# Design Review Subcommittee (DRSC)

**SUBJECT:** Architectural Permit 15-131/ Site Plan Permit 15-315, Los Mares Façade Remodel, a request to remodel an existing commercial building and add additional types of tenants at 635 Camino De Los Mares in the Community Commercial (CC2) Zoning District.

**Image 3: Example Rafter Tail Location**

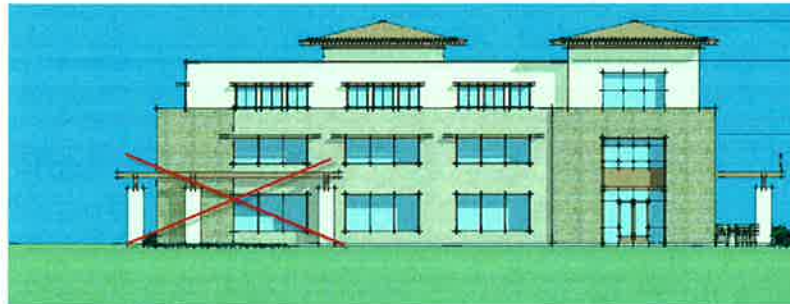
1. **Trellis structure material**-Consistent with the design guidelines, staff recommends utilizing a wood material rather than metal.
2. **Small trellis features above the windows**-Staff recommends the applicant utilize either a wood trellis structure, similar to recommendation 1, or go to a traditional wrought iron and cloth awning.
3. **Tower elements**-Staff recommends a rafter tail element be added to the towers, to provide a traditional architectural element and provide appropriate massing and visual support to the top of the towers. Image 3 shows an example of where the rafter tails need to be located.
